### Harrisville City Planning Commission Harrisville City Offices Wednesday, November 9, 2022 – 7:00 p.m.

## MEMORANDUM

RE: **BEN LOMOND PHASE 2-D SUBDIVISION**  
**Preliminary Plat Submittal**

Our office has completed a review of the preliminary plat and improvement plans for the Harrisville Fields Subdivision located in between North Harrisville Road and 400 North at approximately 375 West. The development is a cluster development and includes 51 single family homes and a large open space area. The Developer is proposing to break up the development into two phases but is requesting preliminary approval of the overall site at this time. If preliminary approval of the entire subdivision is granted, then they will come back to receive final approval for each individual phase.

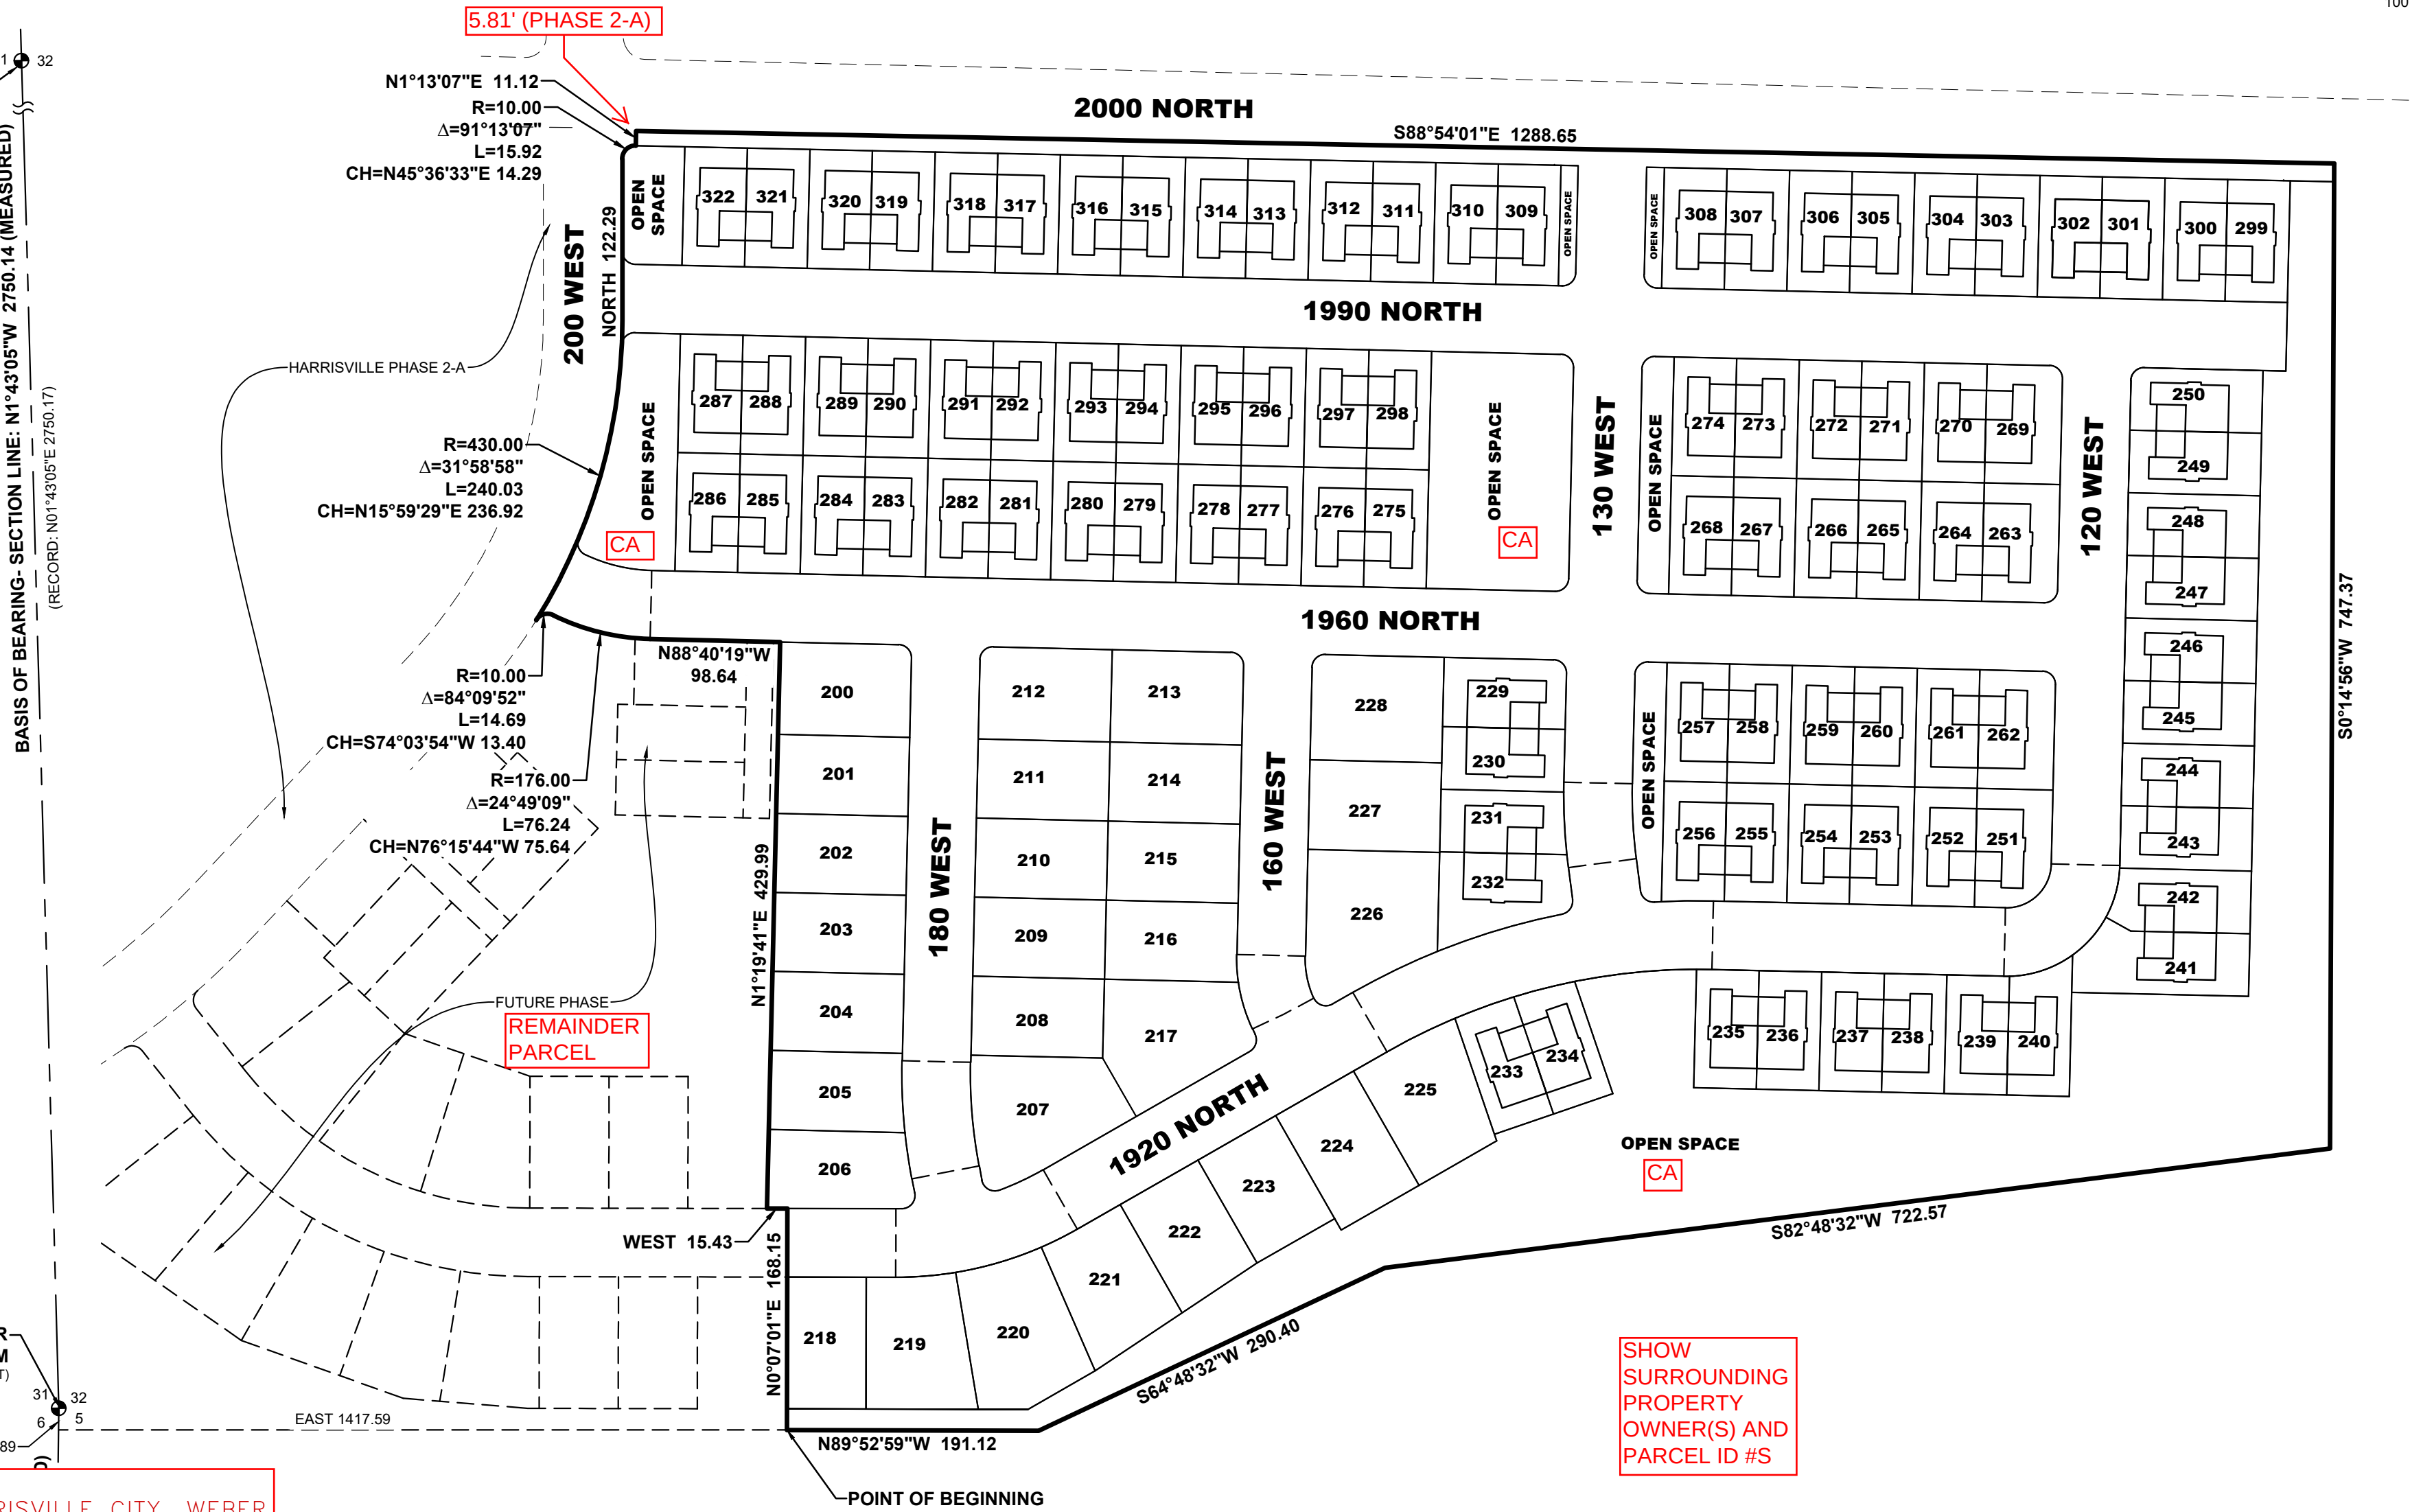
MISSING FROM PLAT:  
1. NARRATIVE  
2. DEVELOPER CONTACT INFORMATION  
3. ALL LOTS ARE TO BE LABELED WITH AN "R" AND HAVE THE LANGUAGE REGARDING GROUNDWATER AND LOWEST FLOOR ELEVATION LIMITATIONS PER CHAPTER 8.07.010 OF CITY CODE  
4. SHOW OUTLINE OF FLOODPLAIN

SHOW WHERE FLOODPLAIN COMES ACROSS THIS AREA - ARE THESE LOTS BUILDABLE AT THIS TIME?

IS THIS AREA BEING DEDICATED AS PART OF 2000 NORTH STREET? SHOULD BE IDENTIFIED AND DEDICATED AS SUCH. SHOULD ALSO SHOW WIDTH OF ROW ON 2000 NORTH AND DISTANCE FROM CENTERLINE TO ROW LINE IN SUBDIVISION.

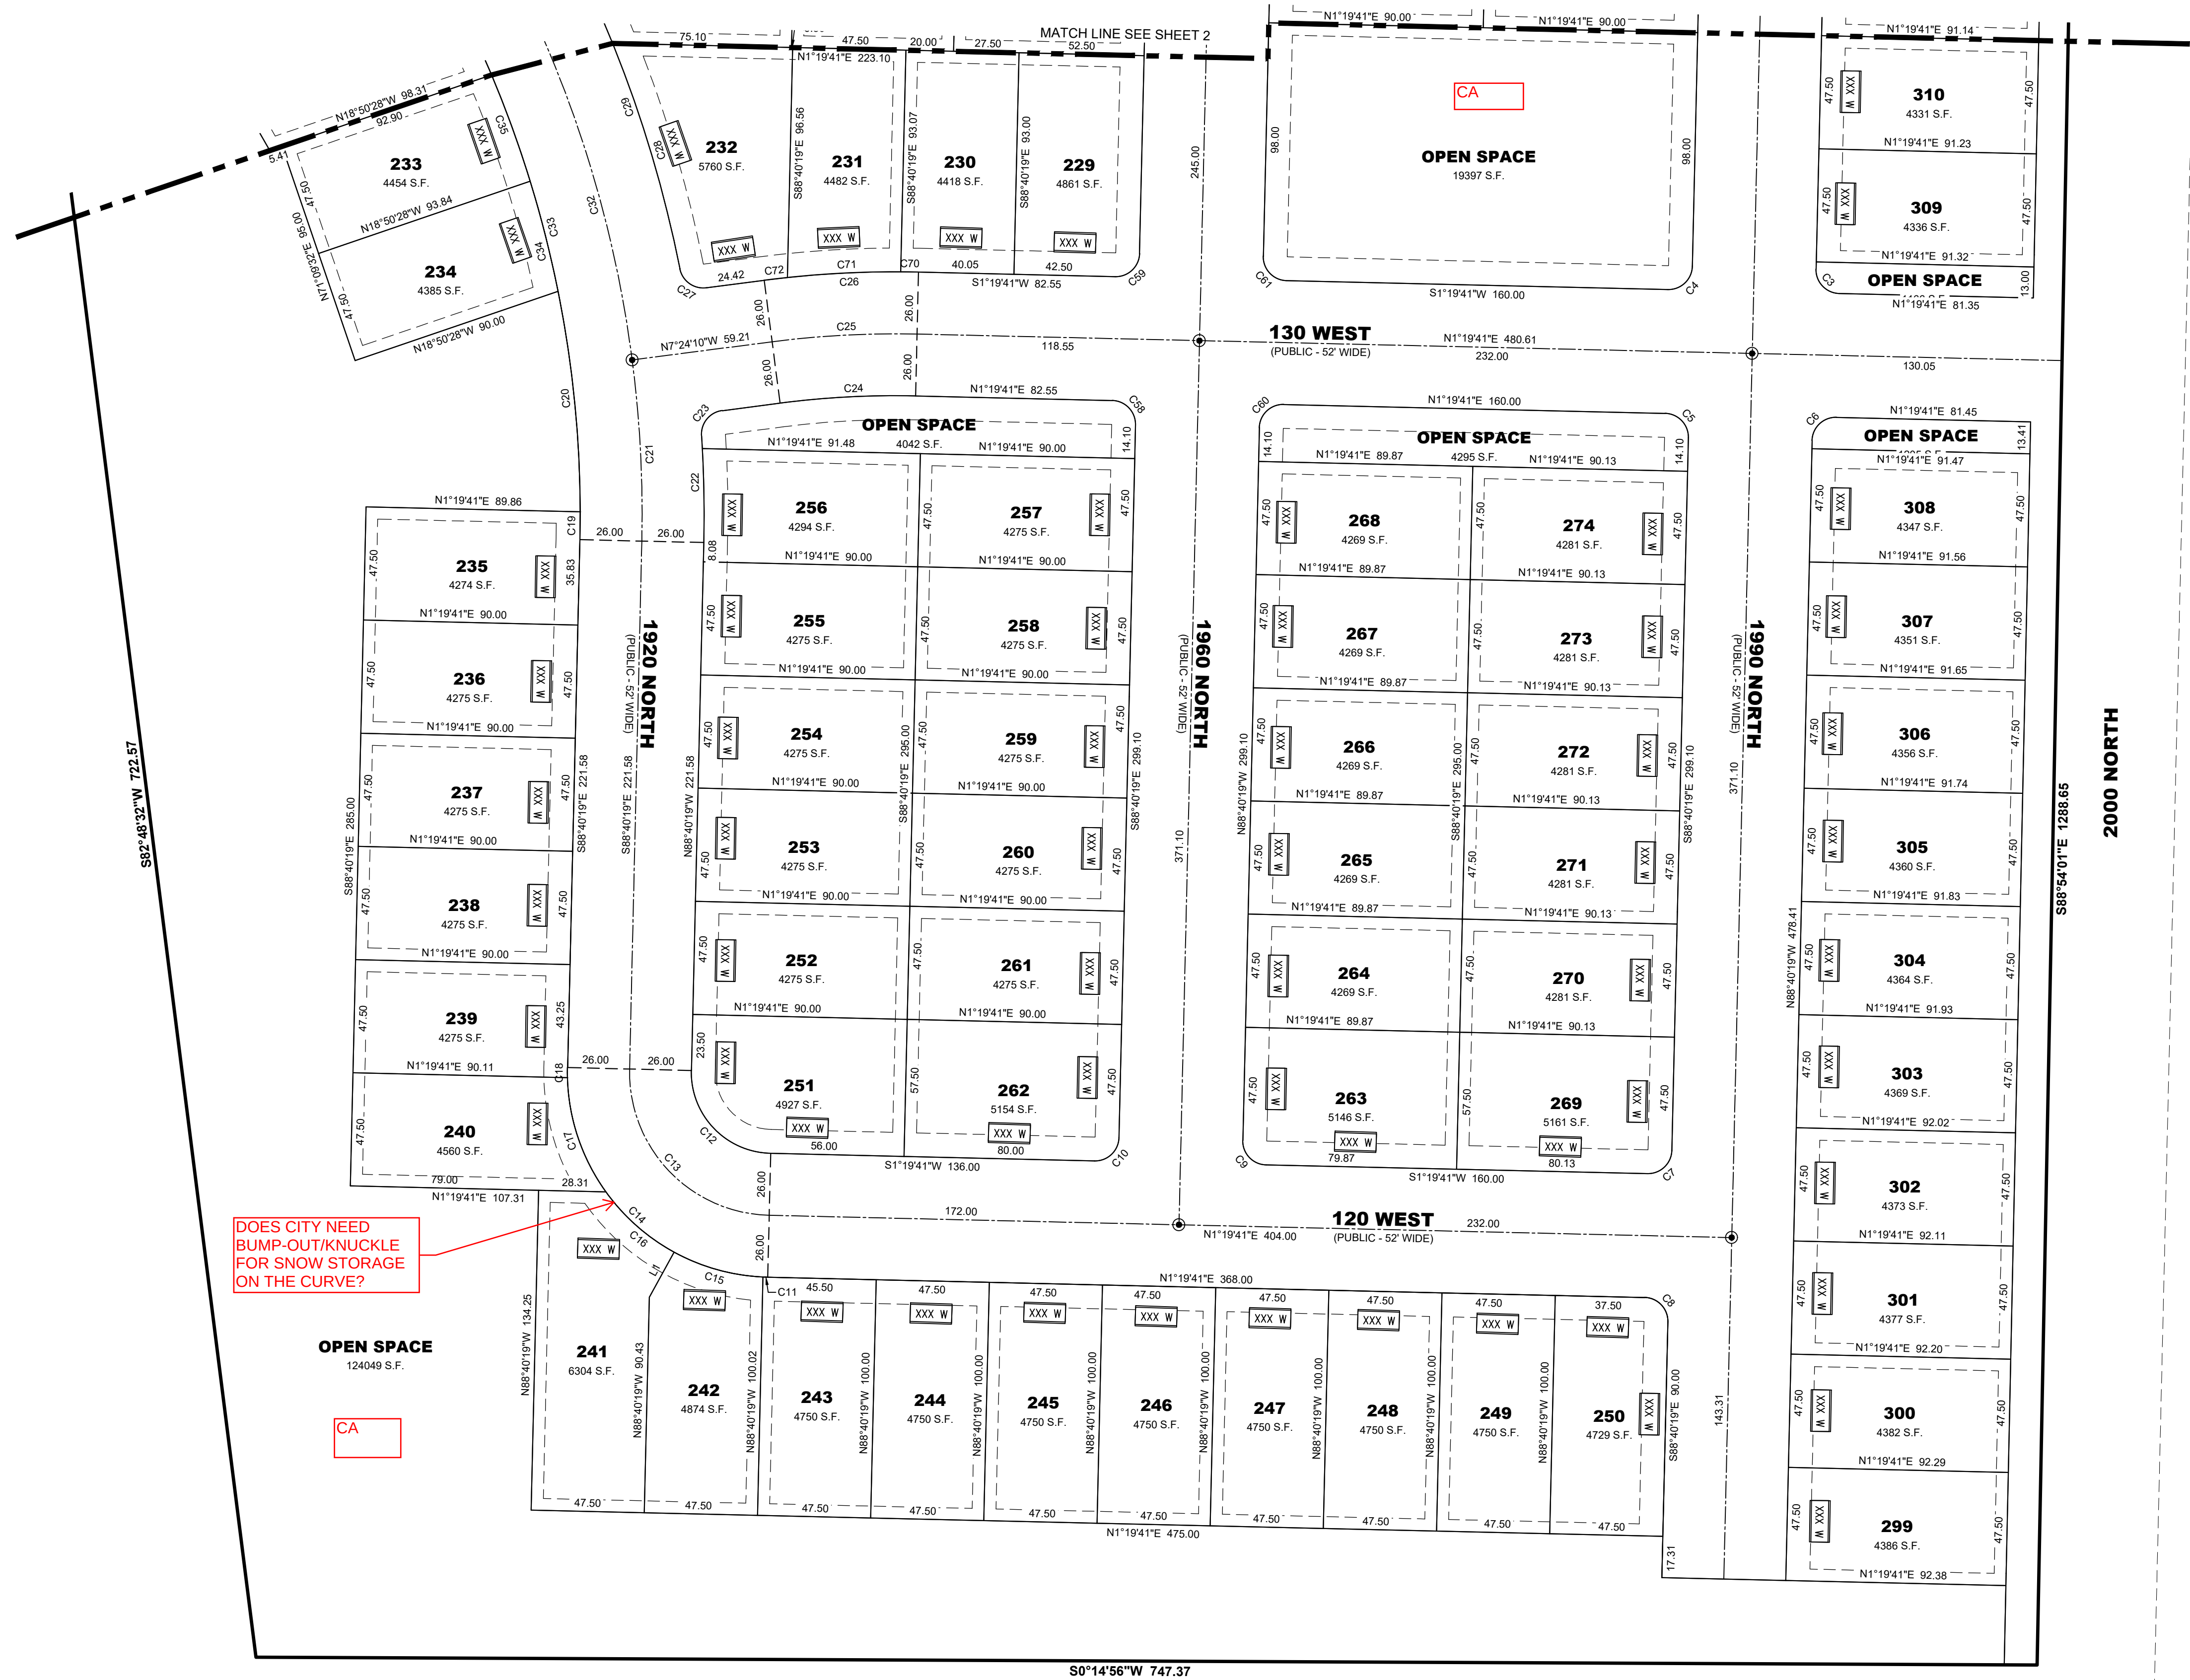
RECORDER'S BLOCK  
REQUIRED ON EACH  
SHEET IN THE BOTTOM  
RIGHT CORNER

1. SHOW PUE DIMENSIONAL  
WIDTHS  
2. ADD LOT ADDRESSES OR  
ADDRESS TABLE

SHOW DUPLEX OUTLINES AS  
IDENTIFIED ON SHEET 1

DETAIL 10

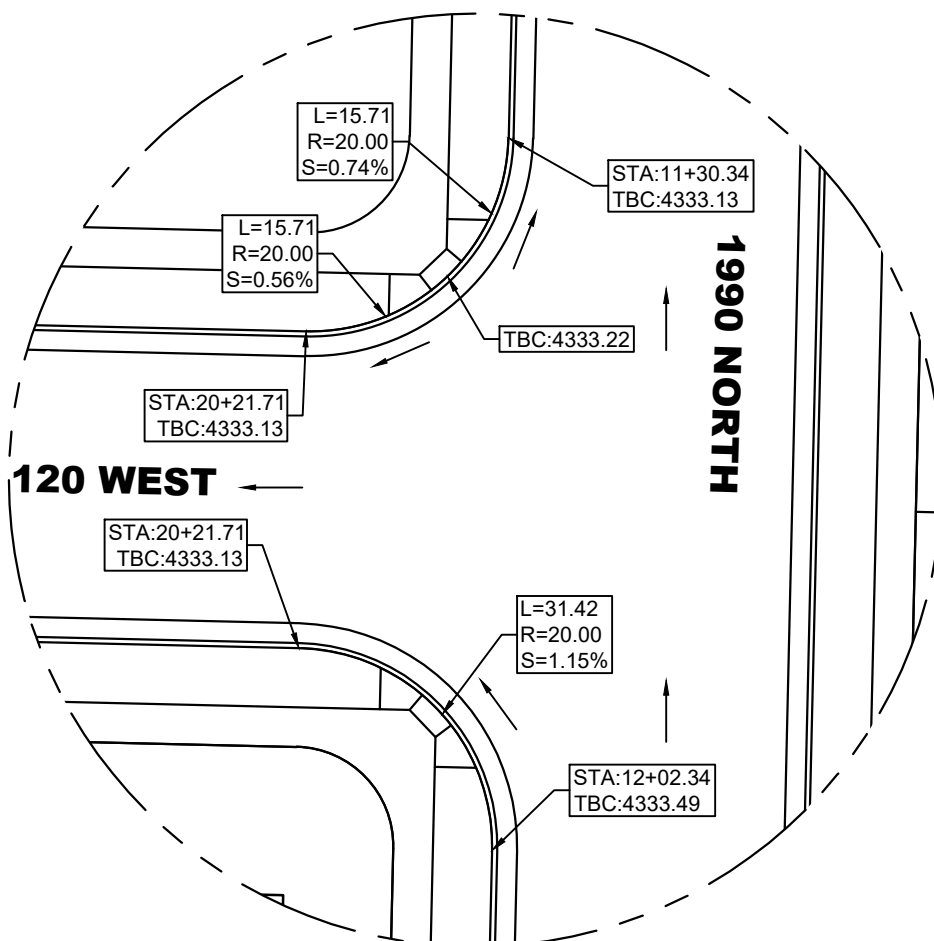
WHERE DOES THIS FLOW GO? IT COMES  
BACK OFF OF 2000 NORTH BUT THEN  
THE GRADE AT THE INTERSECTION TO  
THE SOUTH IS HIGHER.
